SUNDRY NOTICES AND REPORTS ON WELLS

Gumby BAG Federal #1

Yates Petroleum Corporation plans to plug and abandon this well as follows:

Permanent Abandonment of Federal Wells
Conditions of Approval

After

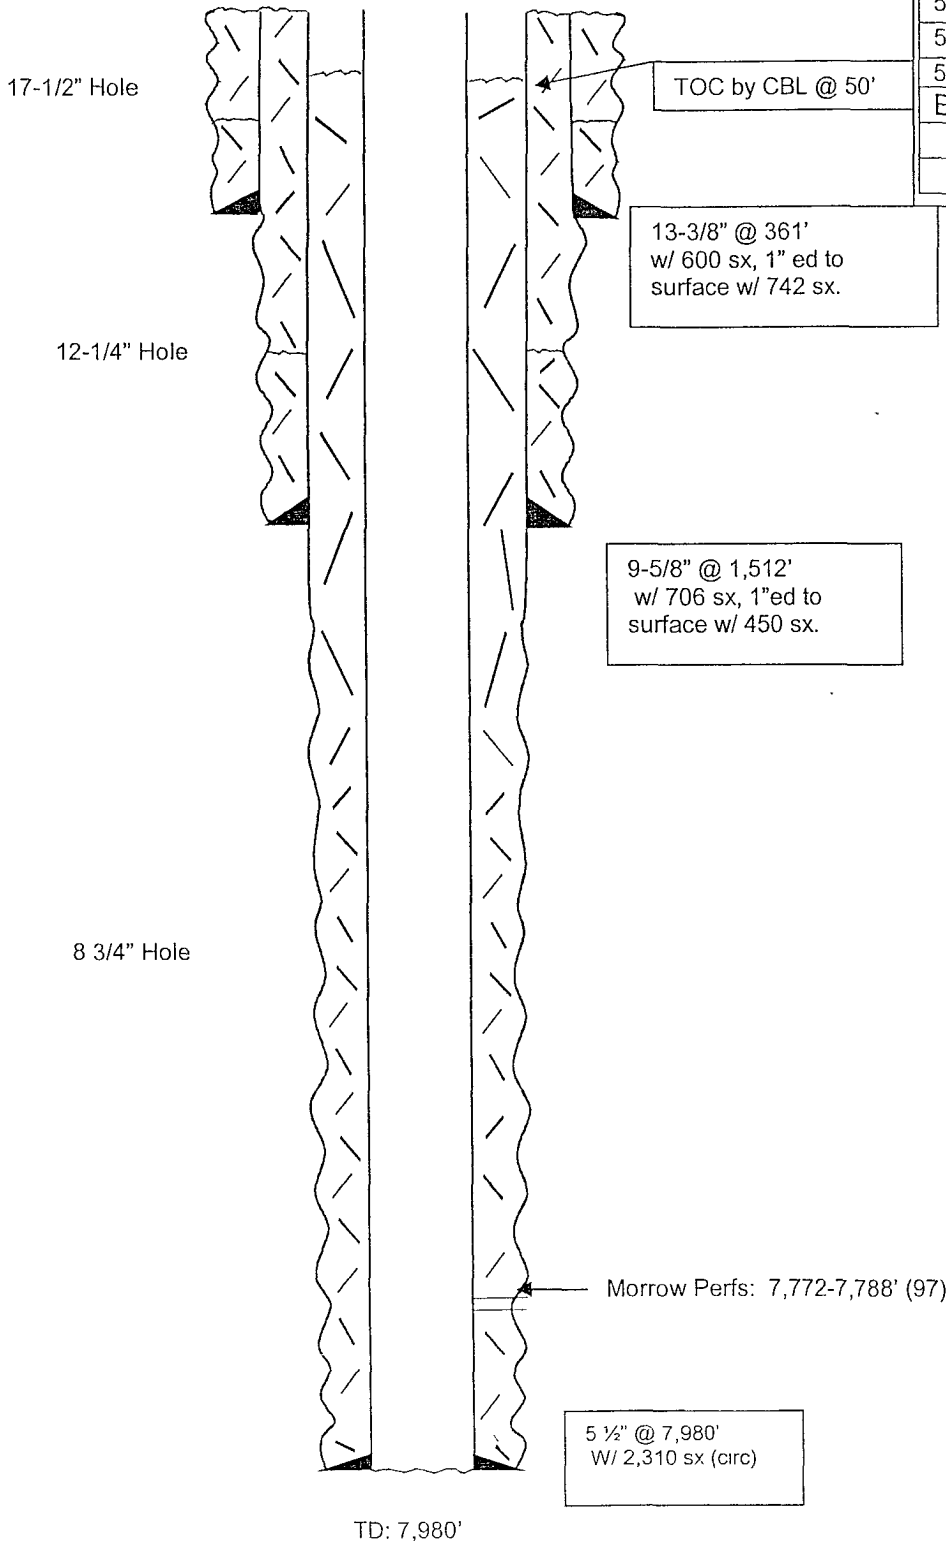
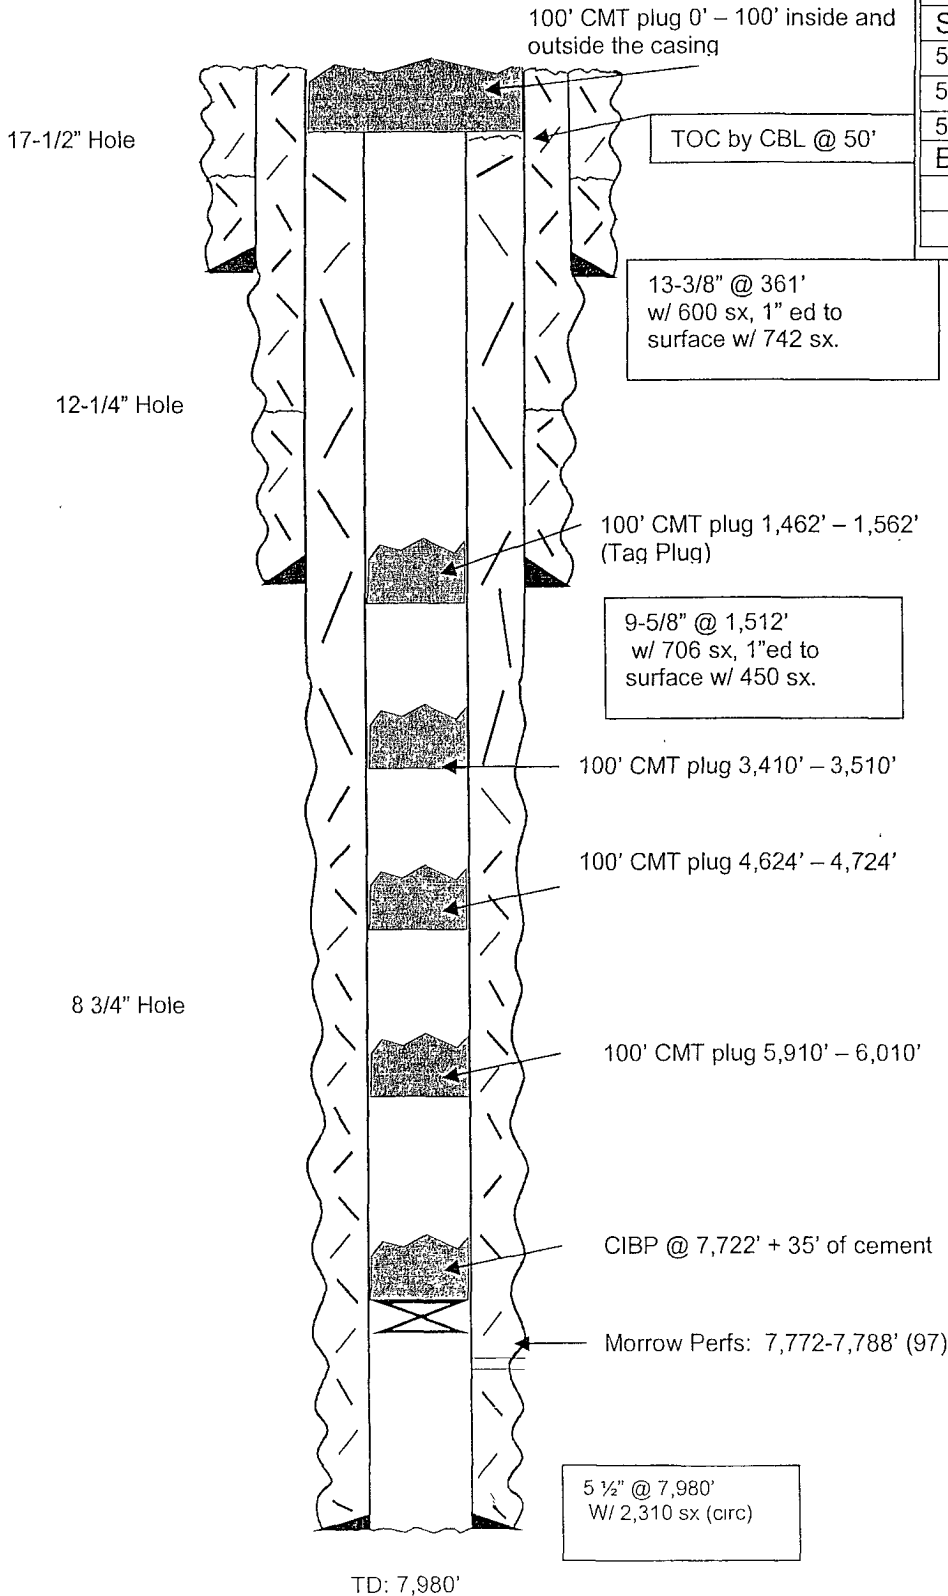
* Plugs Should be 100' plus
10% per 1,000' add 10%
* Surf, Shoe Plug 311'-411'
Tag Plug 100' add plug
